**SOUTH DAKOTA
WATER PERMIT NO. 5775-3**

Application For Permit To Appropriate Water Within The State Of South Dakota

WETLAND MITIGATION PLAN
PRAIRIE GREEN GOLF COURSE

REPORT ON WATER PERMIT APPLICATION NO. 5775-3
CITY OF SIOUX FALLS - PARKS AND RECREATION DEPARTMENT
JUNE 7, 1993

WETLANDS MITIGATION PLAN "B"
SITE ONE MILE NORTHWEST OF LYONS, SD

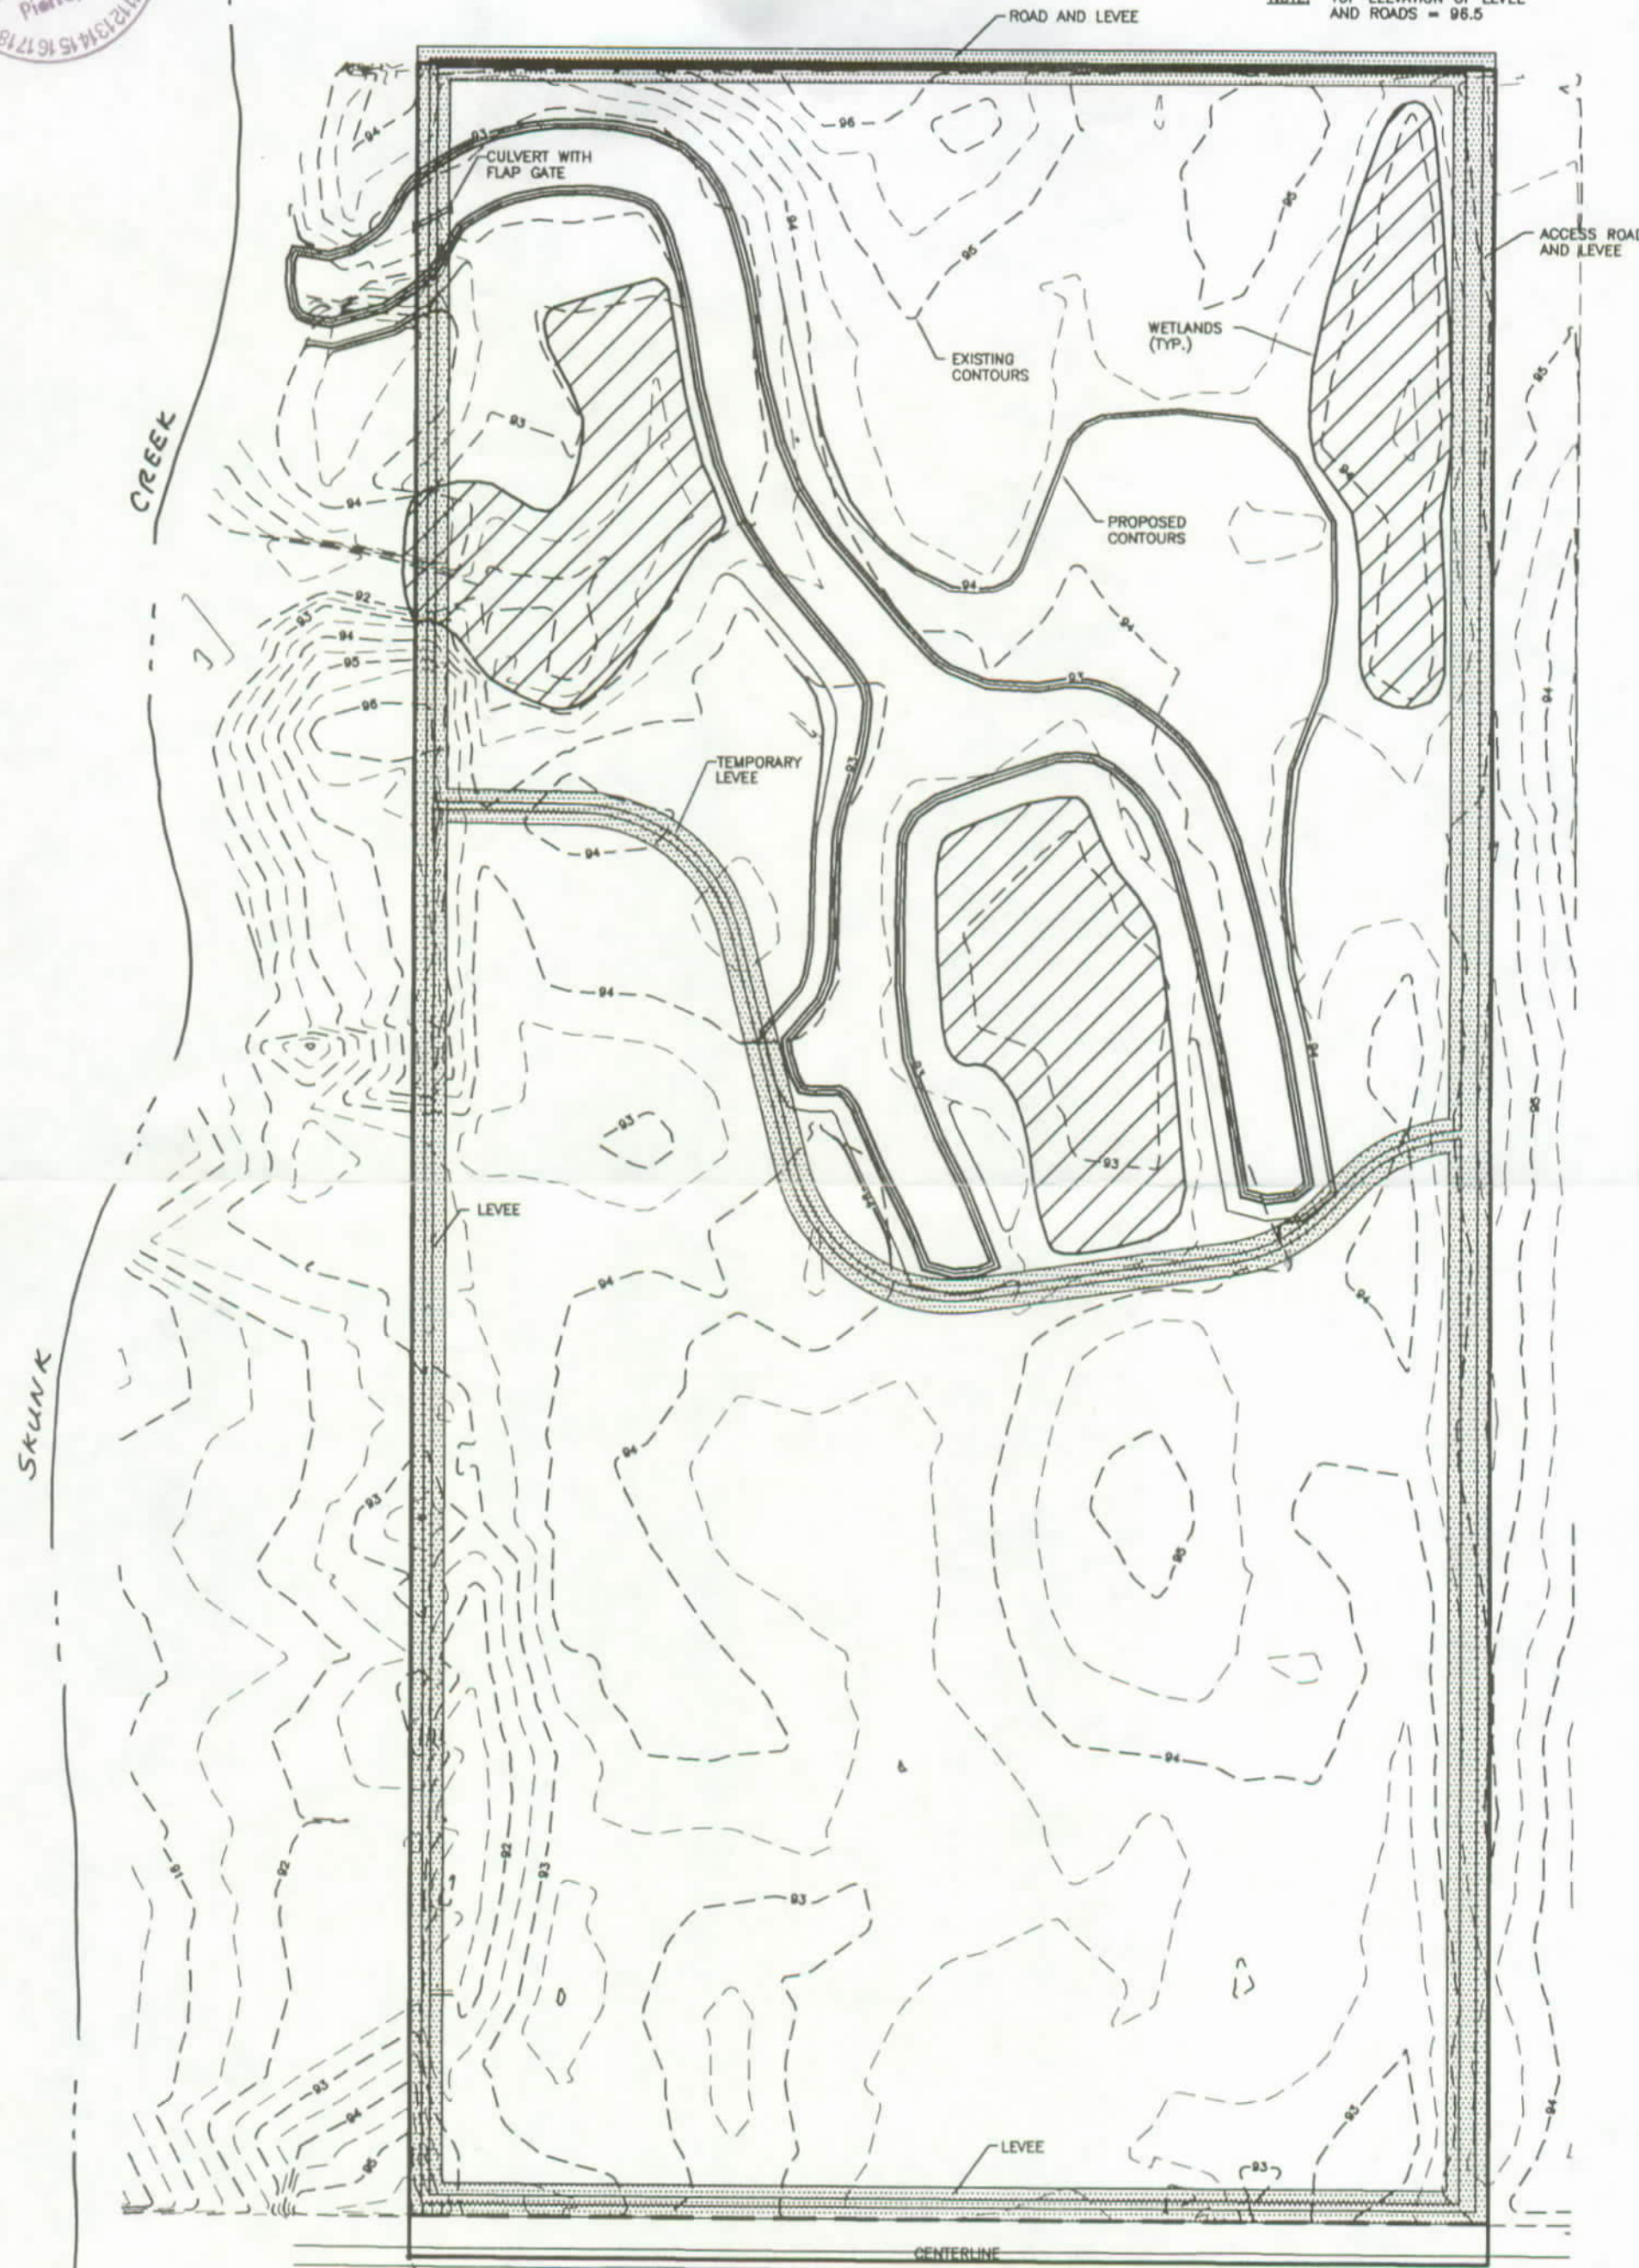
Plans and specifications for the berm will be needed pursuant to Safety of Dams Rules Chapter 74:02:08 (copy of rules enclosed). Since the berm's height is greater than 6 feet, which impounds greater than 50 acre feet, it is by definition considered a dam. A written preliminary risk assessment of the downstream hazard potential needs to be provided in the event that the berm would fail. The risk assessment needs to be prepared by your engineer as defined in the Safety of Dams rules.

Attached is a preliminary design drawing of the proposed off-channel facility. The facility will consist of a containment levee constructed from earth excavated from within the leveed area. The average height of the proposed levee is about 2.5 feet, with the highest part of the levee being 4.5 feet where it crosses the lateral influent channel. The proposed levee would have a top width of 10 feet (20 feet where the top of the levee is to be used as a roadway), with a side slope of 5 to 1. The surface of the levee will be seeded to grass.

During a condition of flooding on Skunk Creek, water will flow into the leveed area through a gated culvert through the levee at the point of the lateral influent channel. Stored water within the leveed area will be lower than the exterior flood elevation on the ascending portion of the flood, and will be higher than the exterior flood level only after significant recession of the exterior flood waters. Since there is no mechanism to produce overtopping of the levee by the empounded water, there is no risk of levee failure by overtopping of the levee by the empounded water. Should a very major flood on Skunk Creek result in temporary inundation of the levee by exterior high flood waters, such will only serve to fill the empounded area to an elevation equal to the exterior flood water level, and will not cause any increase in flood levels downstream of the empoundment over that which would have occurred had the leveed empoundment never been constructed.

Therefore, based on this assessment, it is our professional opinion that this proposed facility does not create a flood risk to the downstream flood plain which is any more than the present risks that exist by virtue of natural riverine flooding phenomena. If anything, the proposed facility may slightly decrease downstream flood risk, by virtue of the volume of flood water which will be detained in the proposed facility.
